Household and similar electrical appliances – Safety –
Part 2-38: Particular requirements for commercial electric griddles and griddle
grills

AMENDMENT 2
AMENDEMENT 2

IEC 60335-2-38:2002/AMD2:2017

Figure 102 – Identification of surfaces for temperature measurement

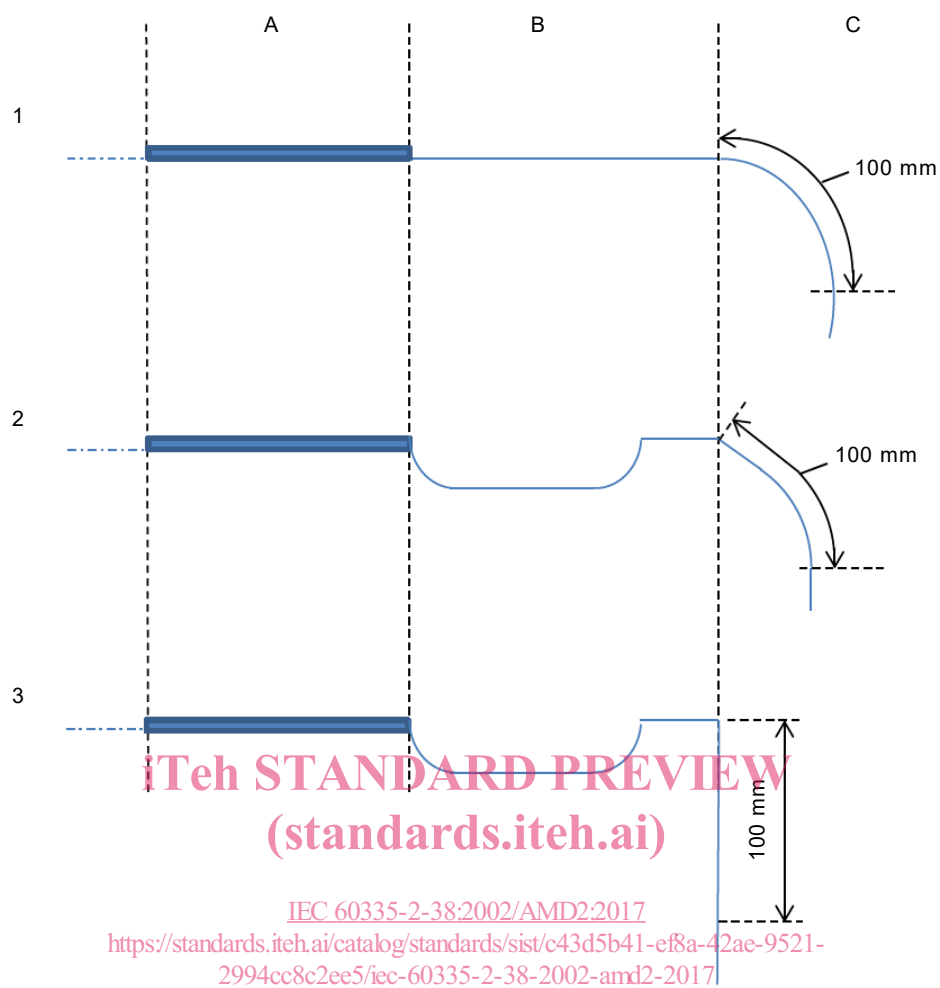
Add the following new figures:

- A **functional surface**
- B **adjacent surface**
- C **external accessible surface**
